TO:	Dr. Cone, Superintendent of Schools, LVISD	FROM:	Catherine Blackler <i>Catherine Blackler</i> Senior Project Manager, AGCM
cc:	Belinda Raindl, LVISD	Michael Rogers,	AGCM
RE:	La Vernia ISD – Bond 2023	DATE:	July 17, 2025
SUBJECT:	PR No. 07R	PR DATE:	July 09 2025
PR COST:	\$ 81,645.00	CONTRACTOR:	Bartlett Cocke (RCO 18)

Description	PR#7R - HS Civil Revisions per RFIs 35 & 82	Date	2025-05-14
Status:	Pending Review	Days Impact:	See Below *

Proposal Request

Architect's Project Number: 22075
Proposal Request Number: 7R
Proposal Request Date: July 9, 2025

C5.00

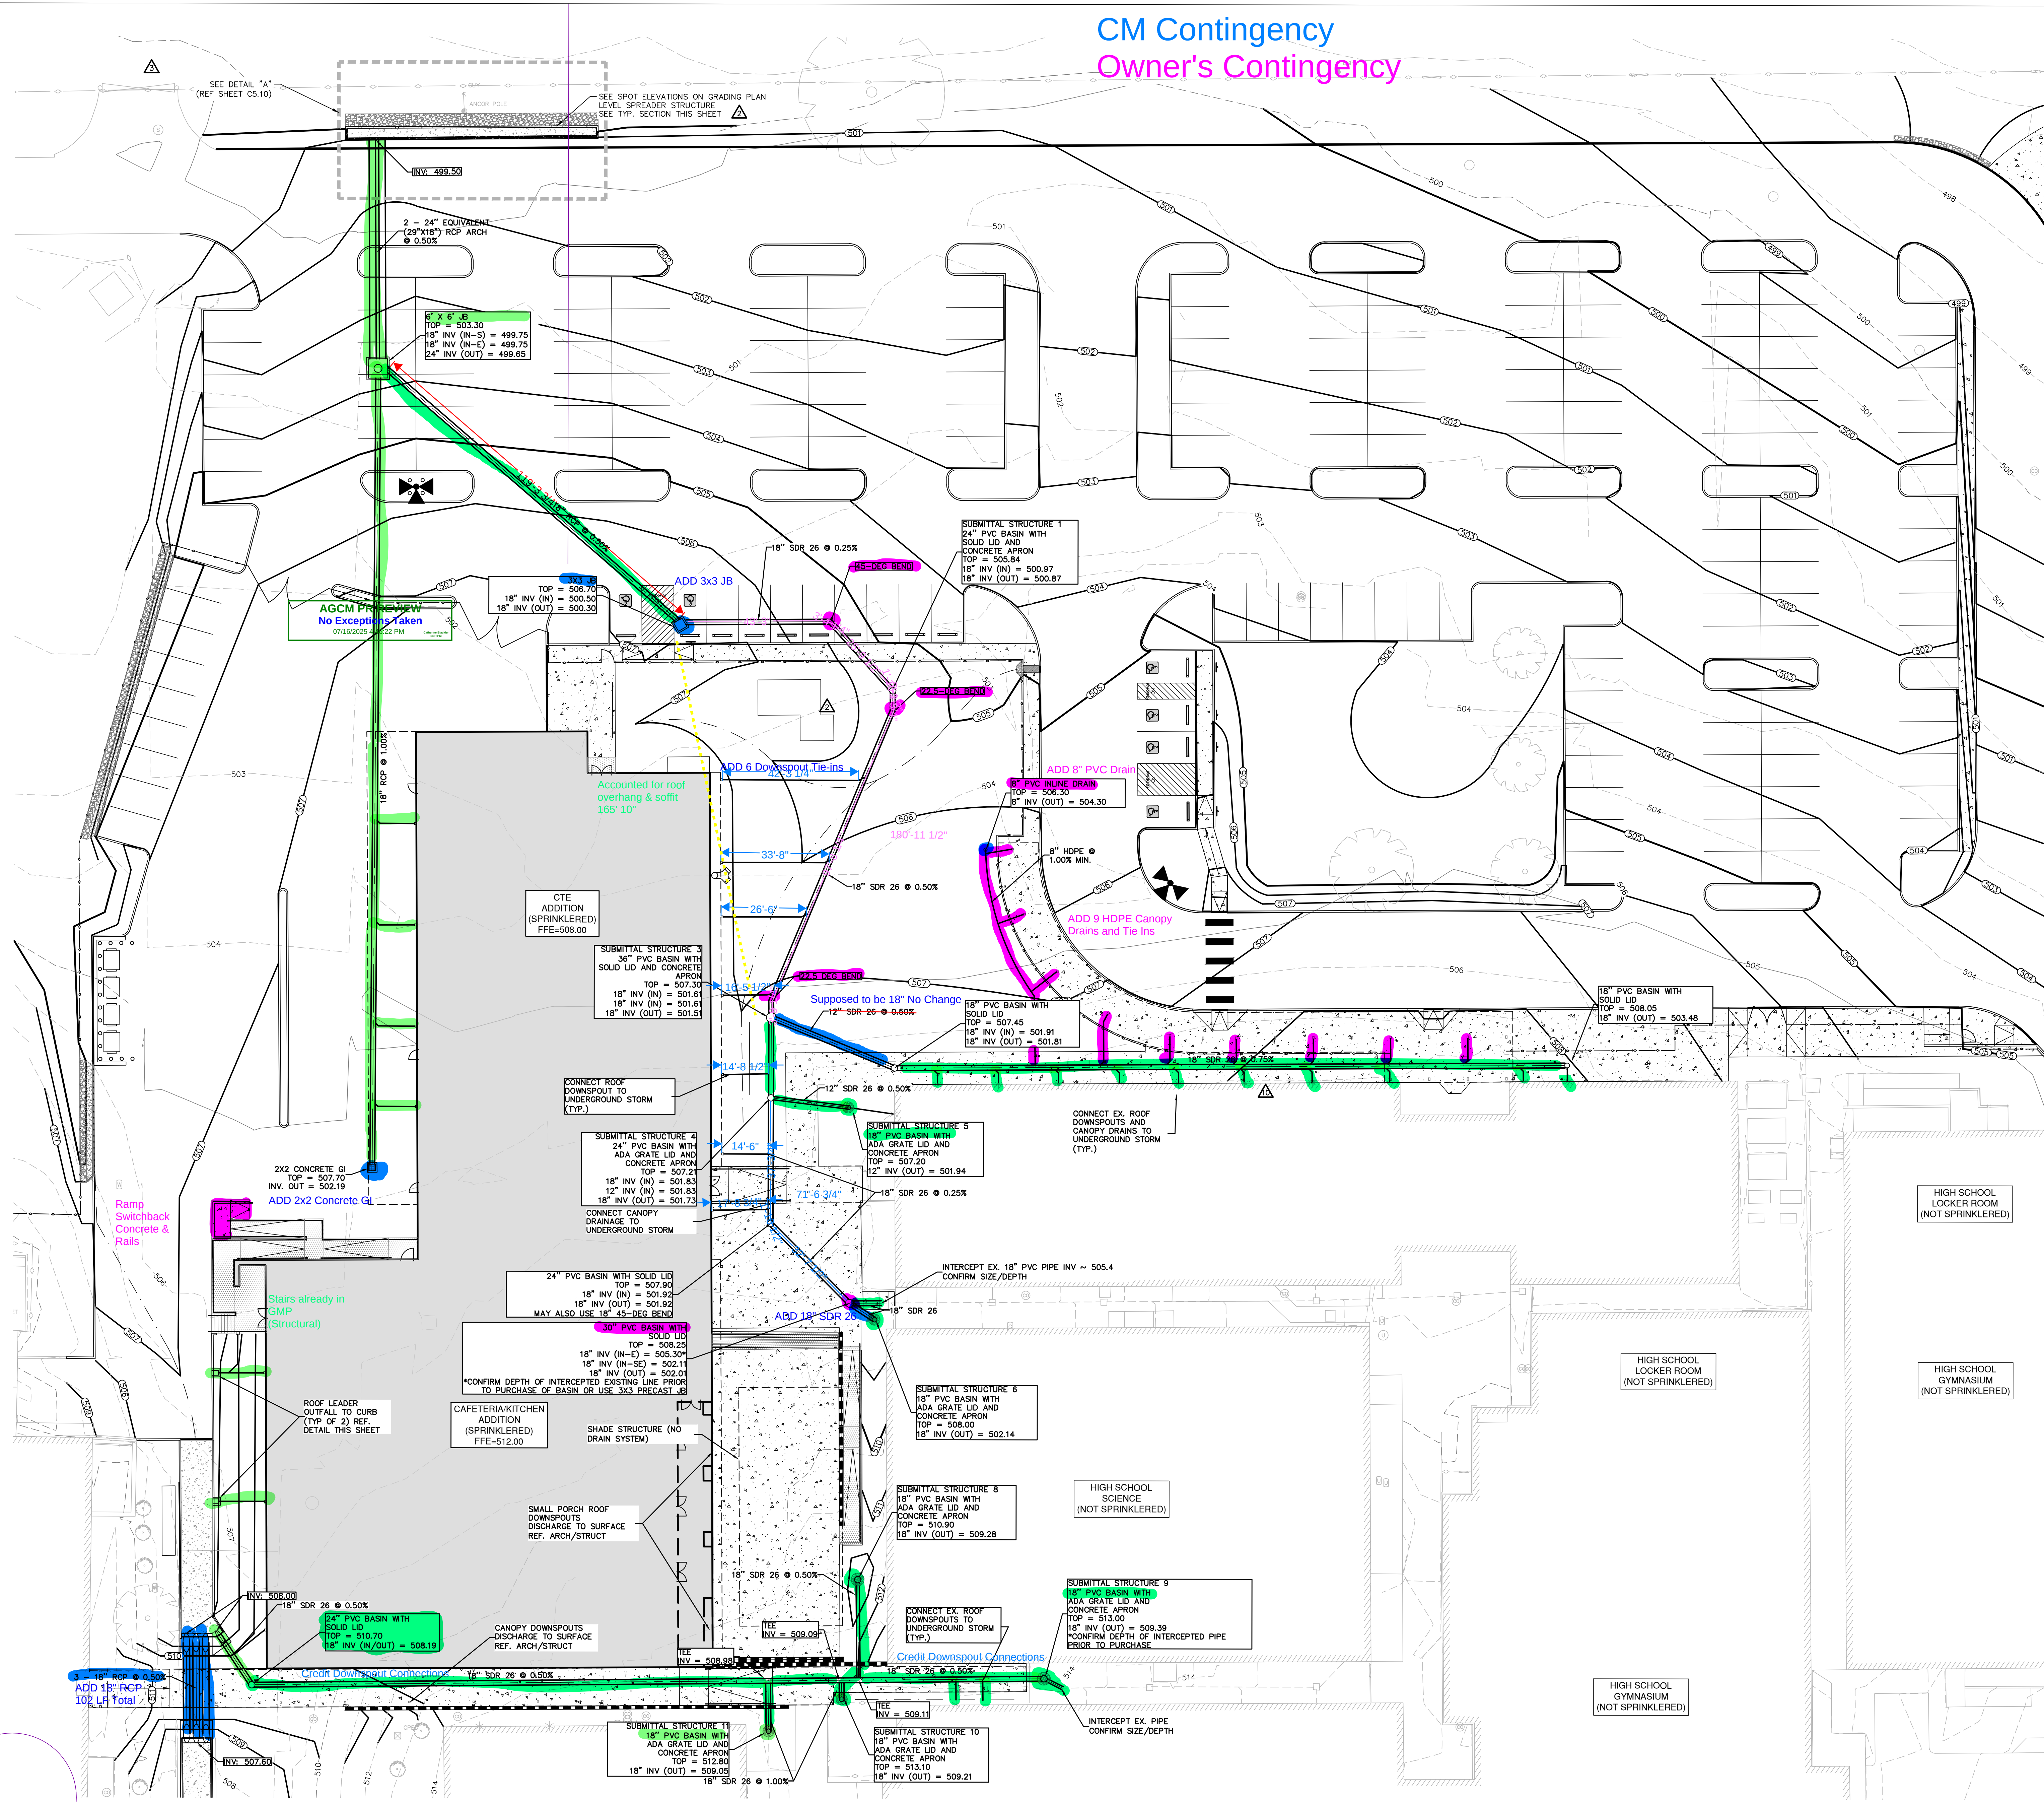
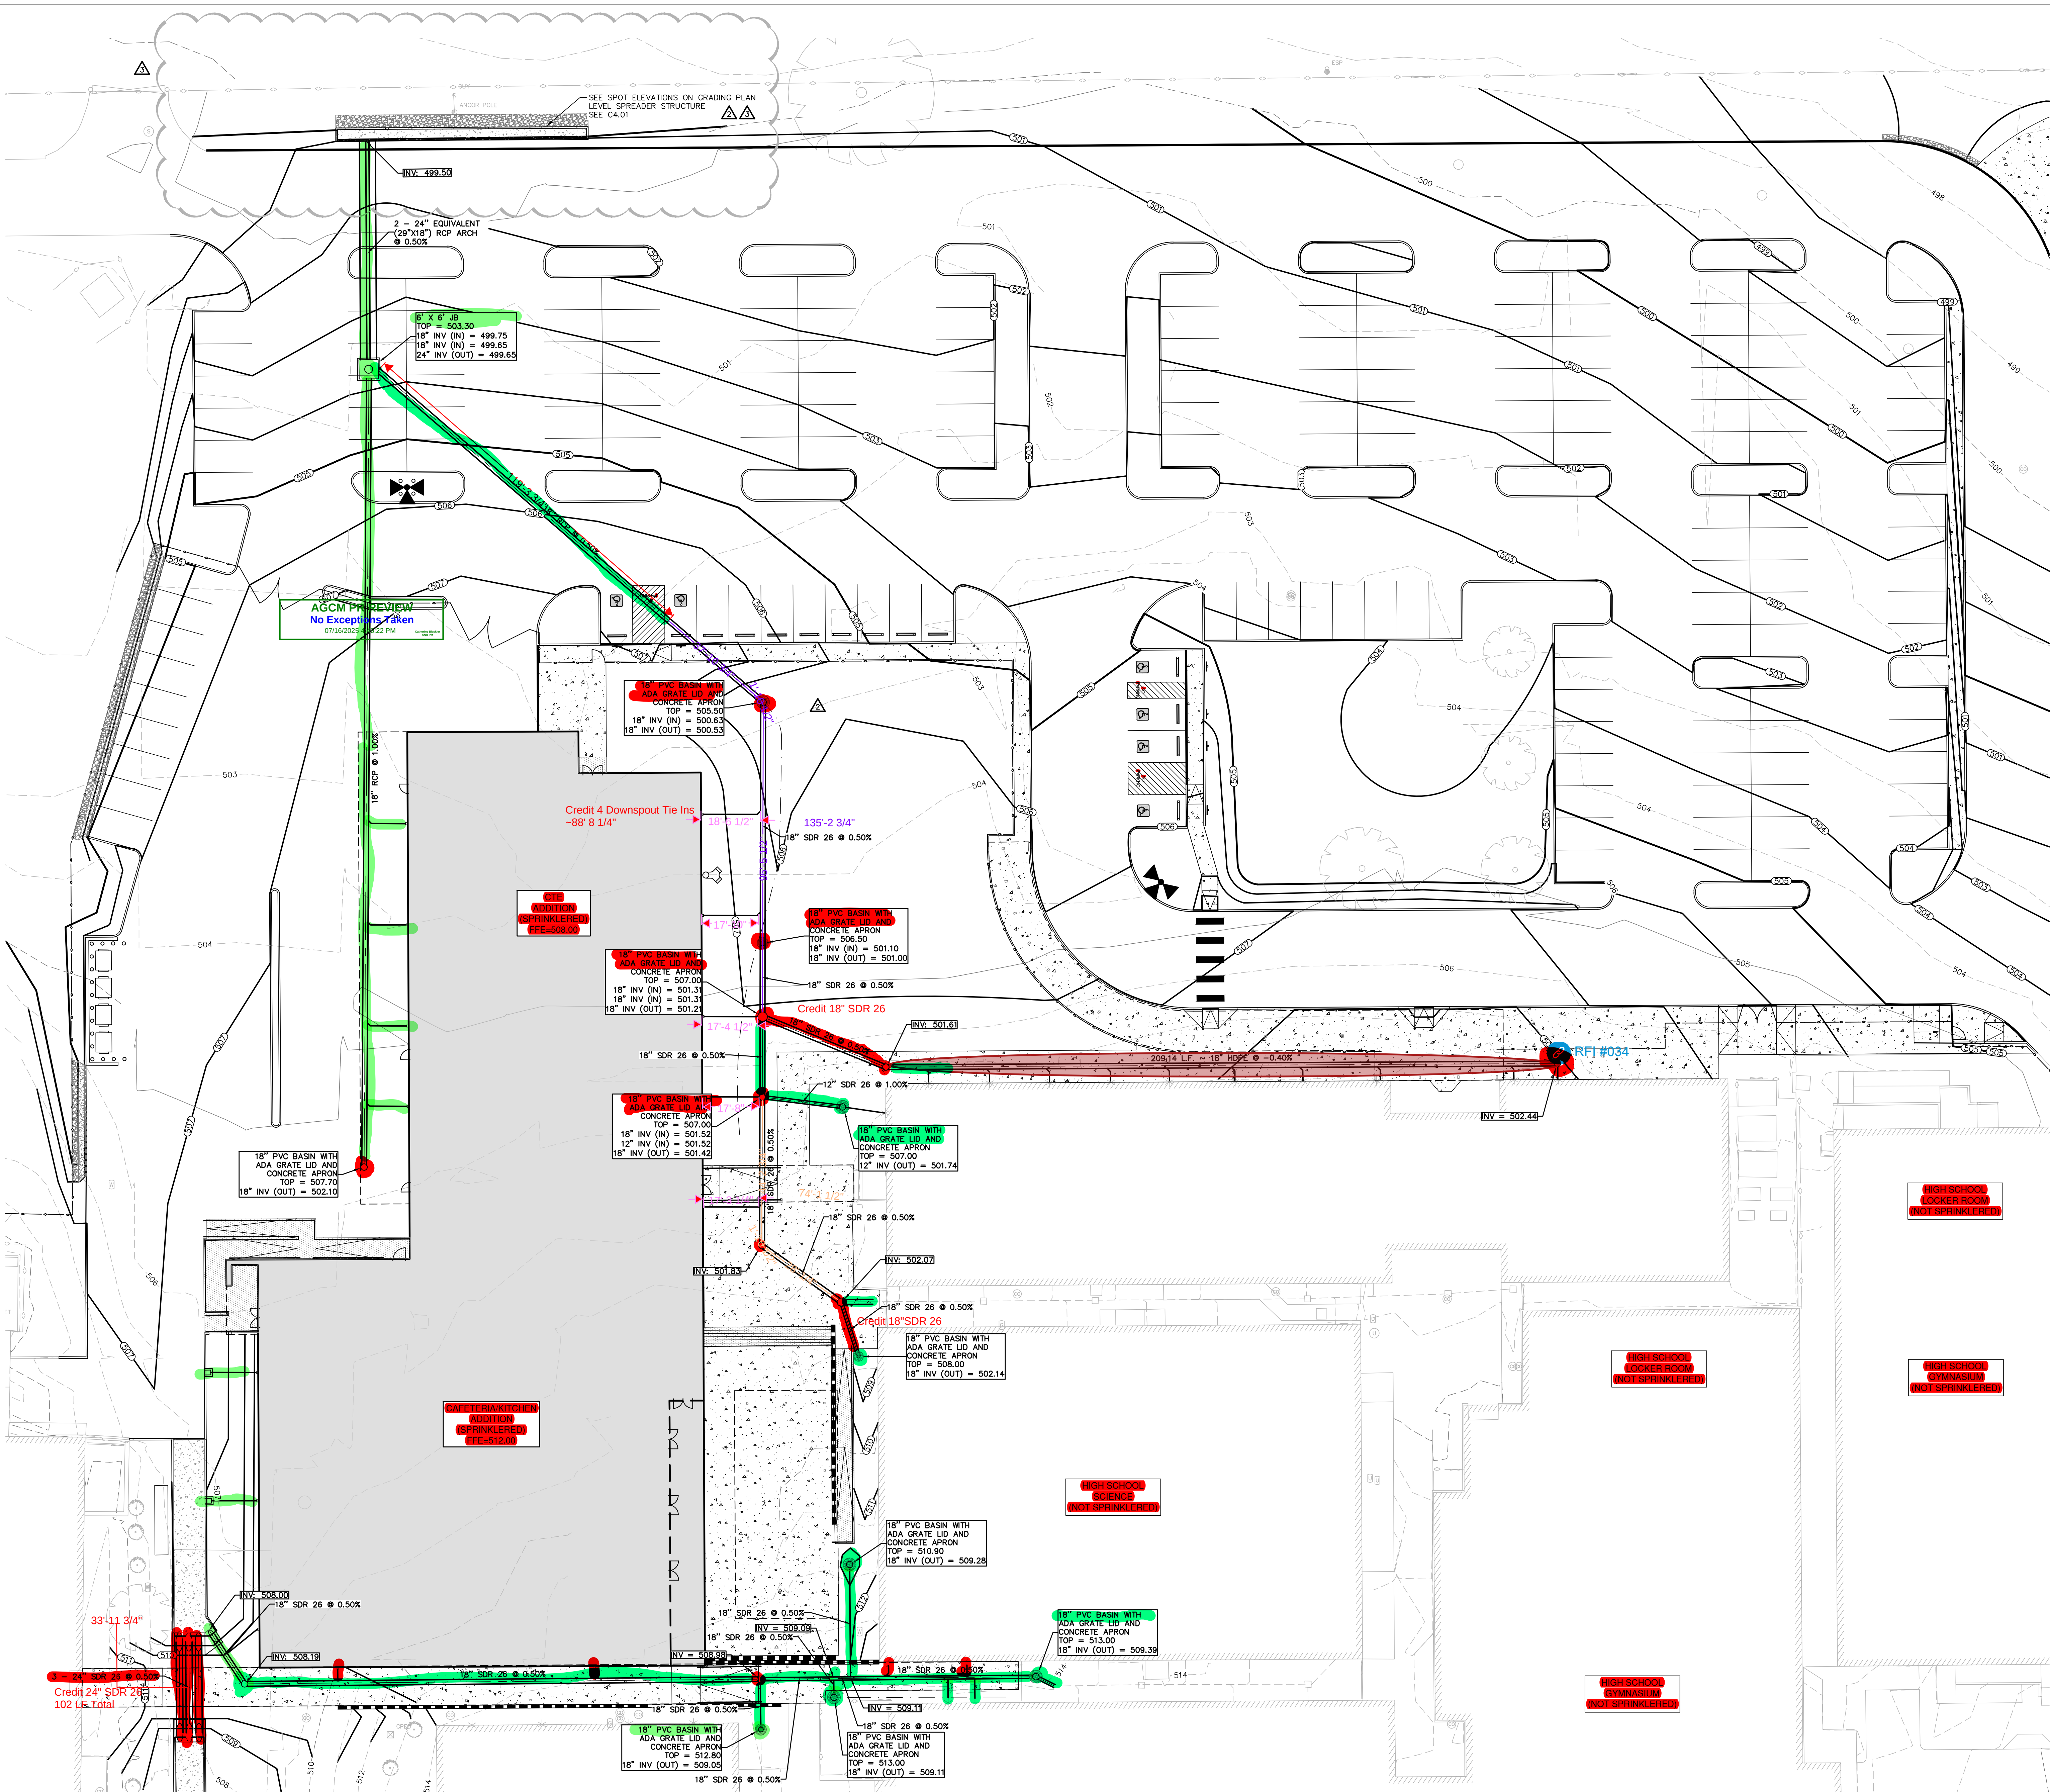
The 18" RCP called out on sheet C5.00 wasn't going to work with the existing catch basin at the start of the line. The OD of the RCP is too large to tie into the basin as shown, and shifting things would've meant demoing the nearby transformer pad.

A few changes were made to the storm drain layout to work around field conflicts. Existing, already-procured materials were reused where possible, with a few new components added to make the system fit and function properly.

Some storm drains, particularly along the CTE building were extended to tie into the revised storm location.

Canopy drains were also added at the bus canopy and tied into the storm system to handle drainage in those areas.
